RE: Submission on Draft Planning Controls for UTS Key Site, Pyrmont Peninsula

UTS INDIGENOUS RESIDENTIAL COLLEGE,
DPIE Review

Draft Pyrmont Peninsula Sub-Precinct Master Plans and Draft Planning Controls Response Report, Design 5 – Architects Pty Ltd 4th February 2022

Figure 1 Envelope comparison

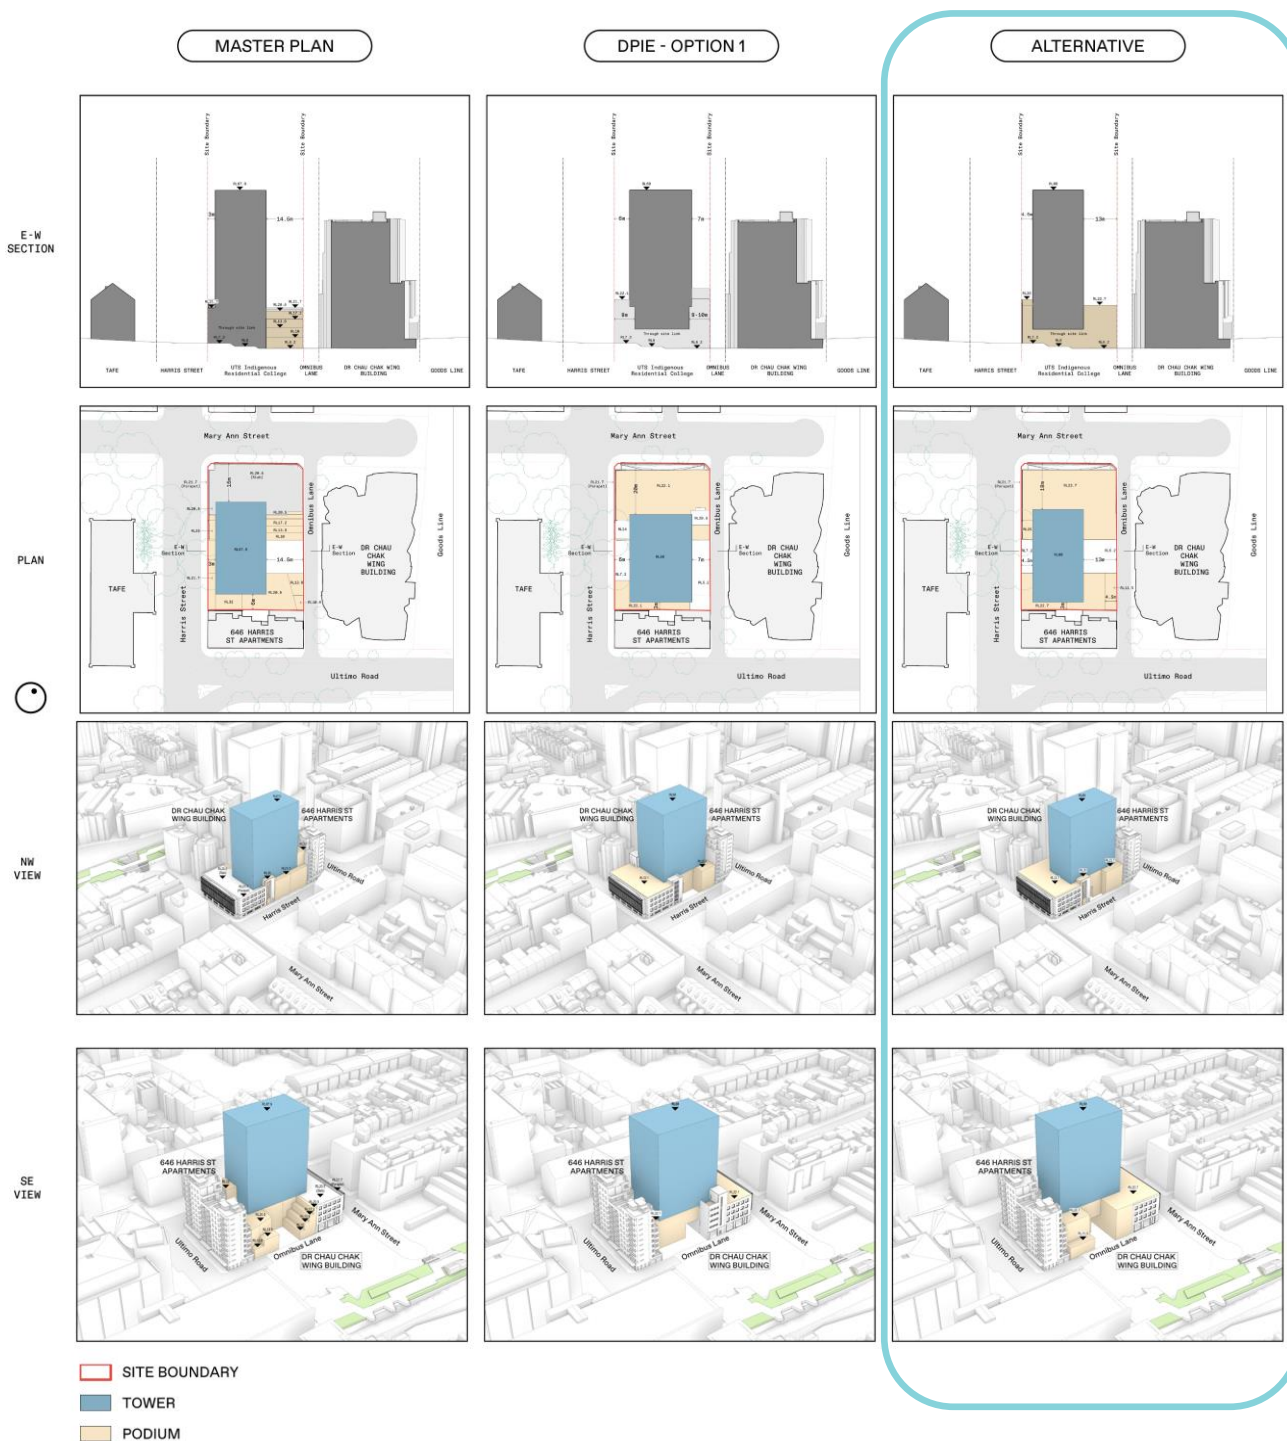
There are however a number of key issues and concerns with the proposed option 1 envelope, and accordingly UTS are proposing an alternative envelope option be adopted by the Department. **Figure 1** below illustrate the proposed alternative envelope, with a comparison against exhibited Option 1 and the UTS submitted Master Plan. **Table 1** also provides a comparison of the tower setbacks. Refer also to **Attachment B**.

- Ensure an integrated and holistic development outcome is able to be achieved;
- Ensure the delivery of a precinct heart (public open space) at the ground plane that is adequately sized and largely open to the sky that is suitable for programmed outdoor performance and direct engagements with the Arts Centre;
- Maximise solar access to the adjoining residential building to the south;
- Support the activation of the precinct heart; and
- Enabling the sensitive intervention to the rear of the heritage building.

Figure 2 Proposed alternative ground floor and public domain plan

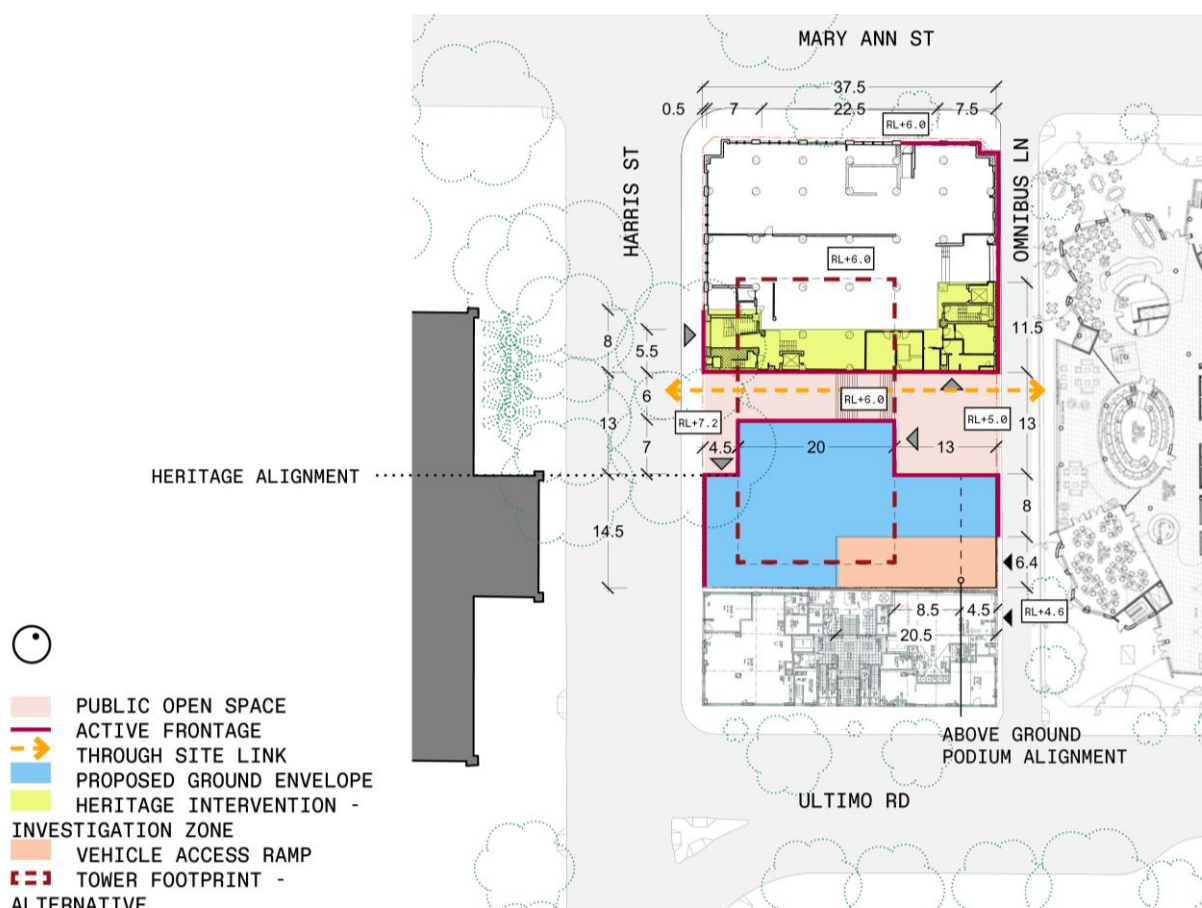
UTS believes its original master plan submission provided for a superior ground plane and public open space outcome. An alternative design and envelope has accordingly been prepared that reinstates the Precinct Heart, with opportunities for improved accessibility and activation between indoor and outdoor spaces, refer to **Figure 2** and **Attachment B**.

Figure 3 Comparison of ground plane

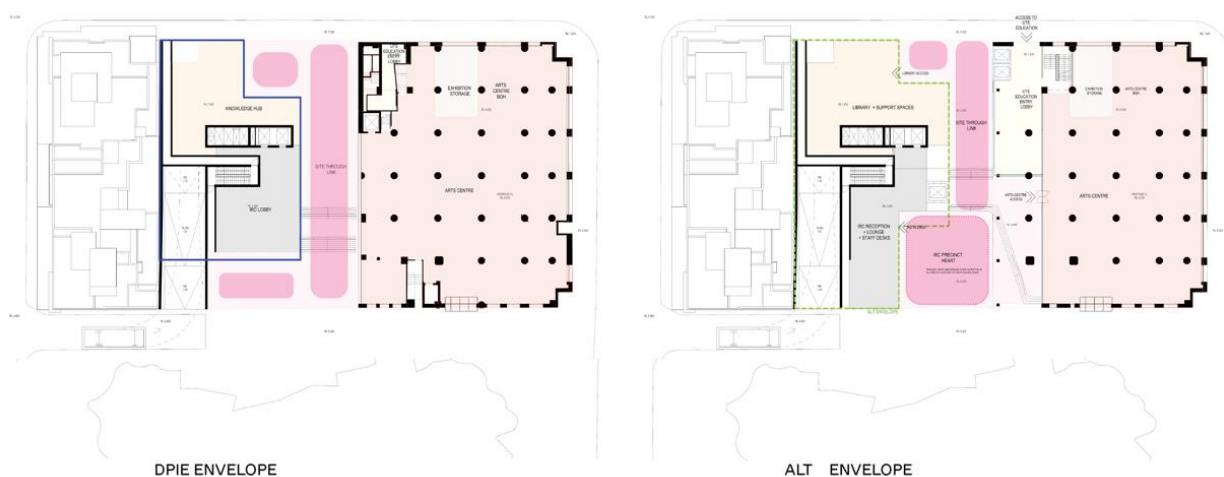
The proposed approach to the ground plane and open space within the exhibited Design Guidelines is at complete odds with the vision by UTS to create a precinct heart for the IRC (refer to **Figure 3**). It should be noted that a new outdoor open space area immediately connected to the proposed Arts Centre to be used in conjunction with that space and for outdoor performances and programming is a key element of the College brief informed by Indigenous people. This will have considerable cultural and public benefits.

An alternative envelope and ground plane is accordingly proposed in order to reinstate what was a crucial element led by and strongly supported by indigenous stakeholders.

Figure 4 Proposed vision and design intent for the central precinct heart

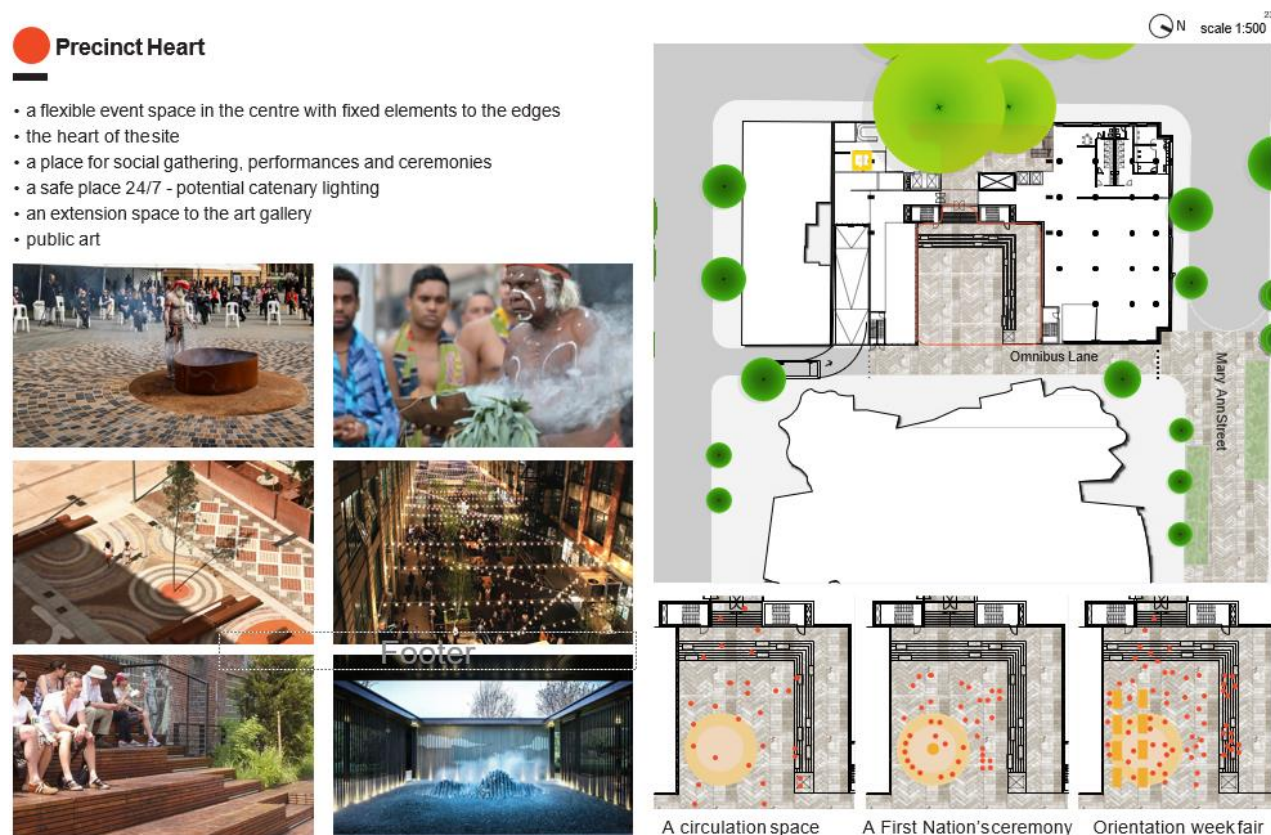
The proposed alternative envelope will support the following benefits and outcomes (refer to **Figure 4**):

- Creating a clearly defined large central area of open space on the ground plane adjoining the Arts Centre that is largely open to the sky;
- Delivering a space that is of a sufficient size to support outdoor performances, ceremonies and programming;

- Providing a space that enables an extension to the functions and program of the Arts Centre;
- Delivering a physical and symbolic heart for the IRC that is grounded and activated; and
- Prioritising the delivery of open space that is located away from Harris Street, which does not provide ideal conditions in terms of noise and solar access.

Figure 5 Precinct heart solar access studies

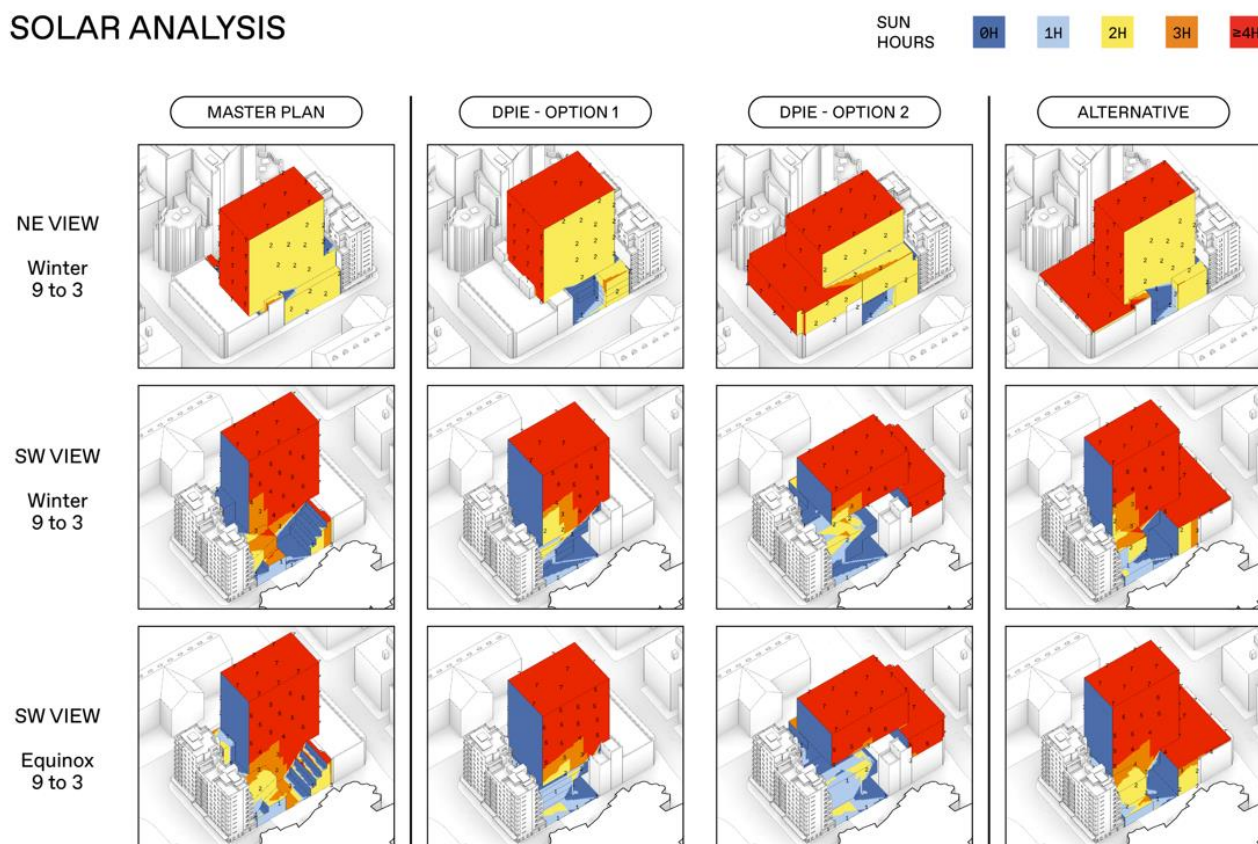
Detailed modelling undertaken by BVN as part of the UTS Master Plan submission demonstrated the amount of solar access achievable to the precinct heart. Updated modelling, including in relation to the alternative envelope now being proposed by UTS has been prepared and included at **Attachment B** (refer to **Figure 5**).

The greatest opportunity to optimising solar access to the precinct heart centres around the interface of the heritage building to the north. The reference design prepared in support of the master plan submission demonstrated one approach whereby partial demolition and stepping the rear of the heritage building enabled achievement of 2 hours of solar access to 50% during Equinox.

If the heritage building is required as is now proposed to be retained in its entirety, this greatly diminishes any opportunity to provide any improvements to solar access beyond the existing shaded situation.

It is proposed that this design challenge is best resolved as part of the design competition phase, where designers are able to test levels of intervention to the heritage building while also balancing desires to optimise solar access to the precinct, in particular during Equinox.

Ground Floor COMPARISON

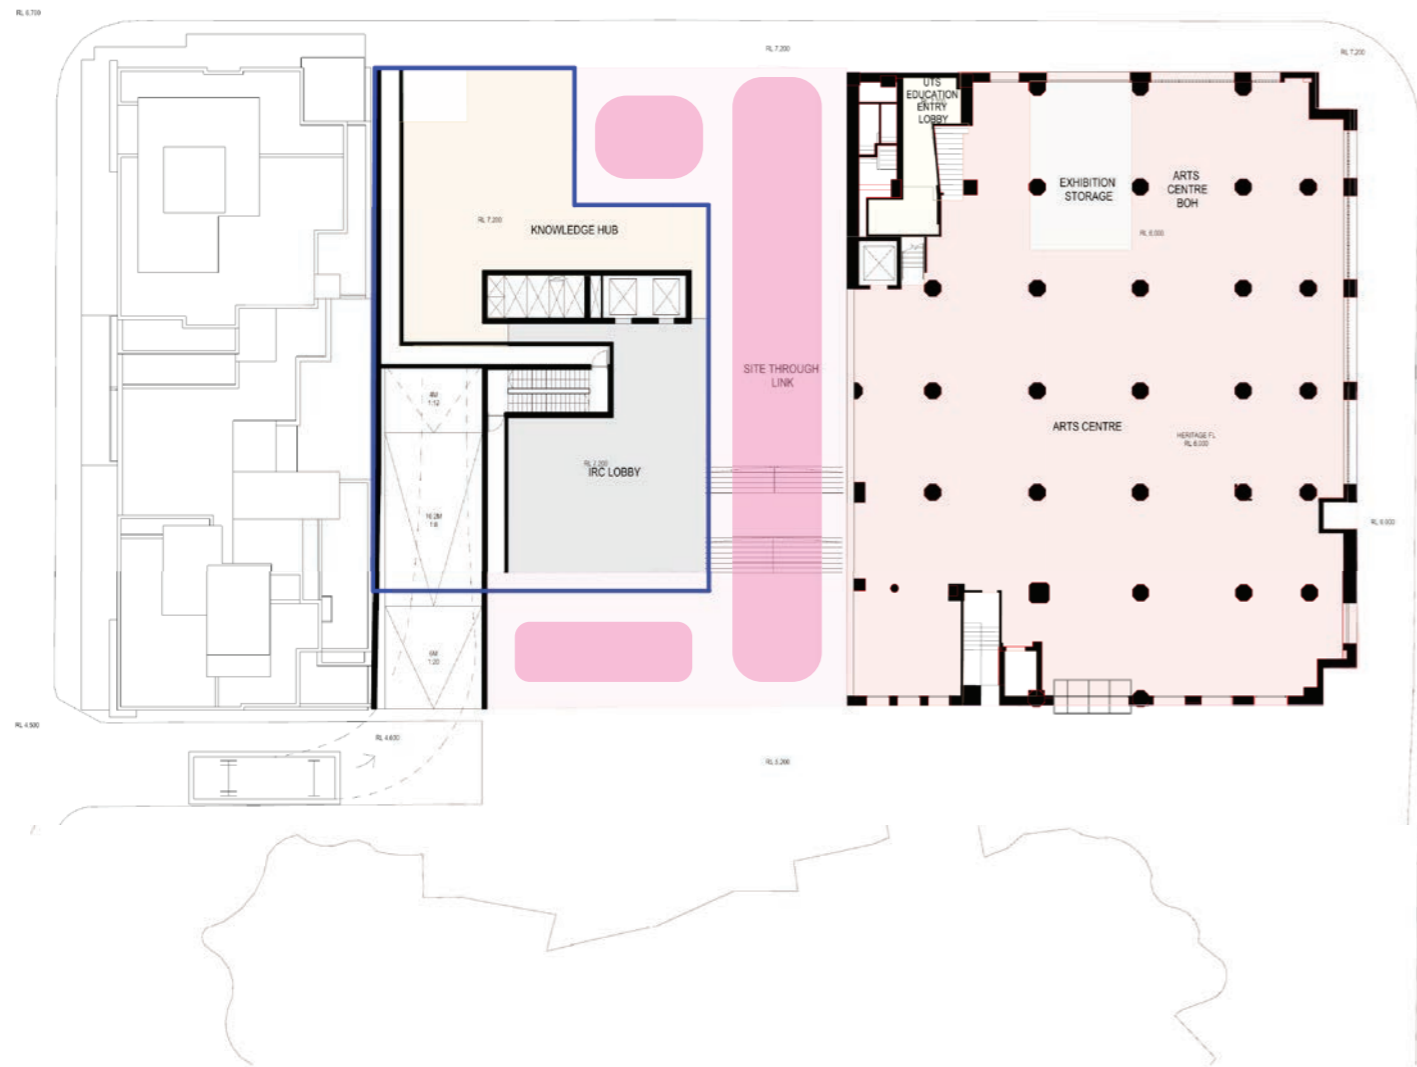
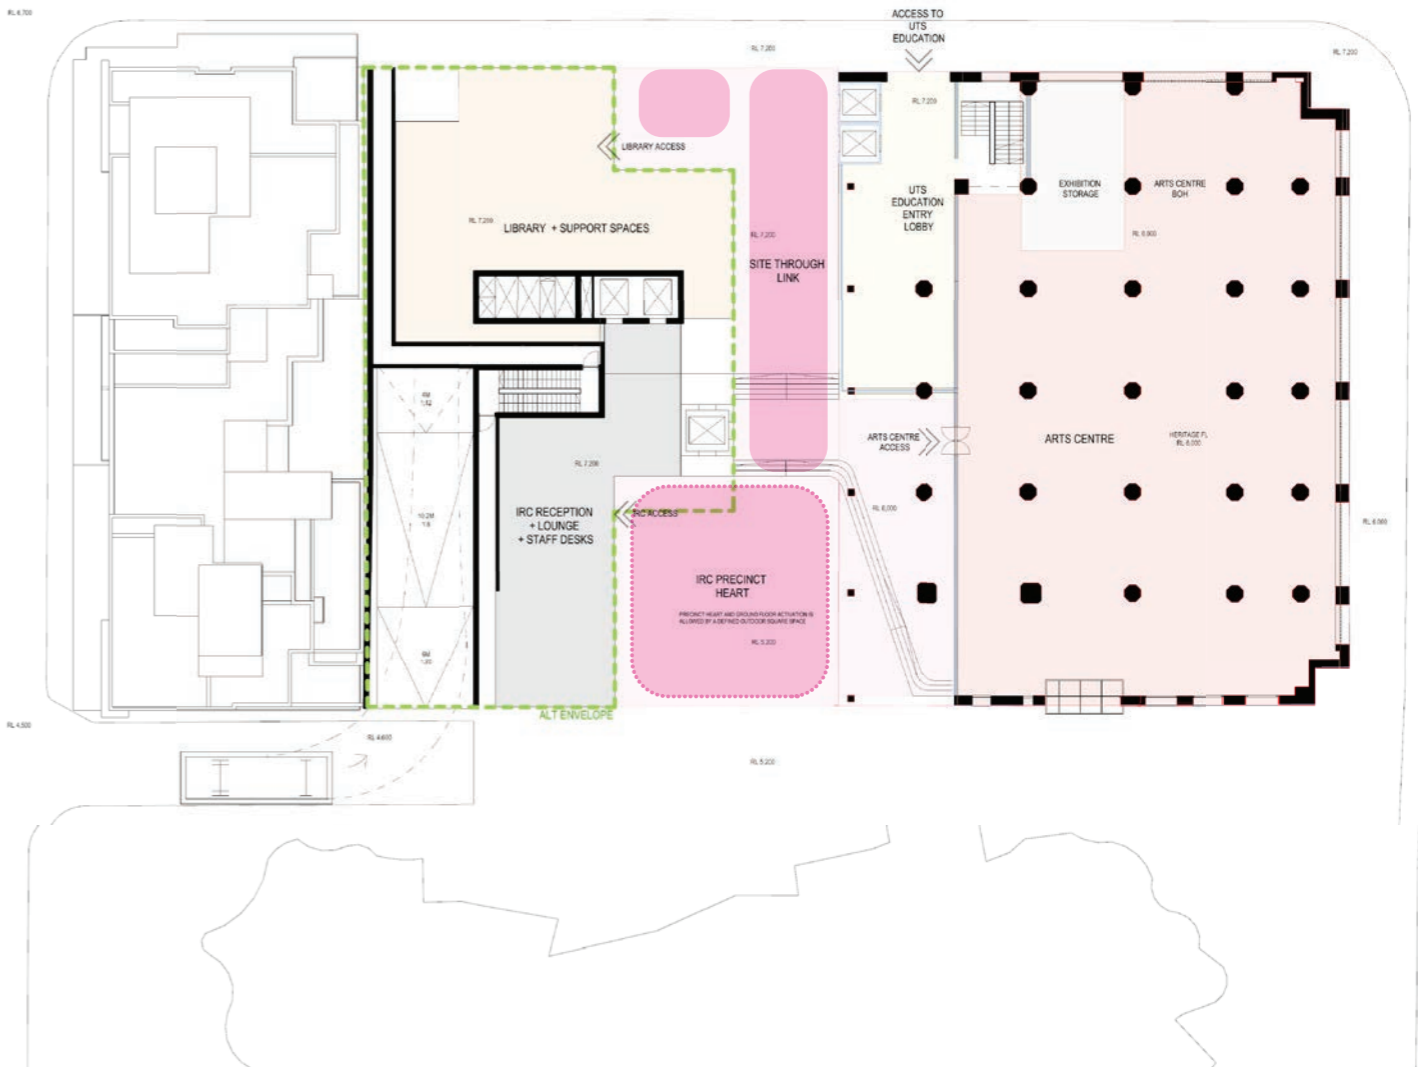
Ground activation is not achieved due to lack of defined outdoor spaces. Site through link is perceived as a tunnel.

Figure 11 – Proposed building envelope for UTS residential college
(Design Guidelines, 2021 (Hassell))

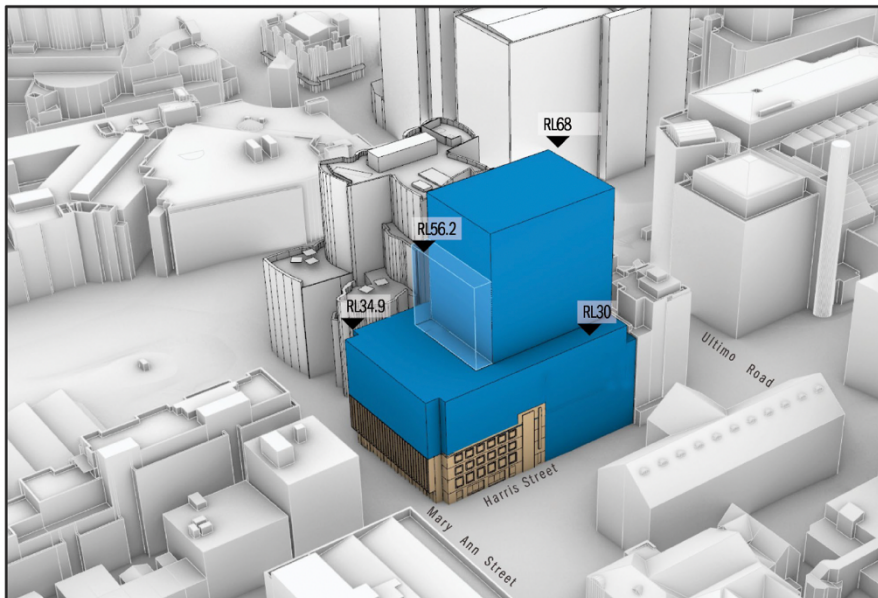
The proposed envelope in Figure 1 above does not respect the significance, setting or context of the NCR Building or comply with the conservation policies outlined in the CMP. The envelope as shown will result in a totally inappropriate and detrimental outcome, substantially and adversely impacting the heritage significance of the NCR Building, and its context and setting. The NCR Building with this envelope would be substantially overpowered and diminished visually and architecturally. The envelope will also result in reduction in access to sunlight to the apartments to the south.

Block additions immediately above the NCR Building would provide a floor plate that would be completely inappropriate for residential uses, particularly for an Indigenous College where 'Connection to Country' and access to sunlight and views would be considered fundamental. Such an envelope could work for educational use but would still be completely inappropriate on this building.
